Product Change Notification

Date Issued :	July 02, 2024	PCN Number :	515293
Reason for Change :	Packaging Method/Quantity Changing		
Description of Change :	This notification is to inform you about part(s) listed will undergo changes for packaging size/ packaging specification change. No changes will be made to product as part of this change.		
Assessment of Change :	Supplier Qualification Test Report/s		
Planned Implementation Date :	January 03, 2025		
Customer Sample Availability Date:	July 31, 2024		
Last date to request Samples by Customer : July 31, 2024			
Please note if Samples are not requested as per Customer Samples Request date, it may take additional 4-6 weeks to arrange Samples.

Before Picture

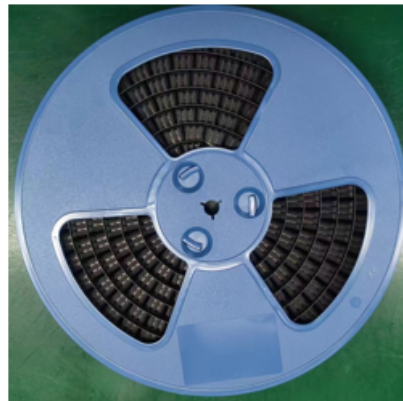
- Change packing tape reel from paper trays to plastic trays

- Change packing tape reel from paper trays to plastic trays for enhance packaging protect capabilities.
- Product Impact:
No impact to fit, form or function;
- Part Number Impact:
 - See attached impacted parts list
- Qualification Reports and samples available upon request after the date shown above
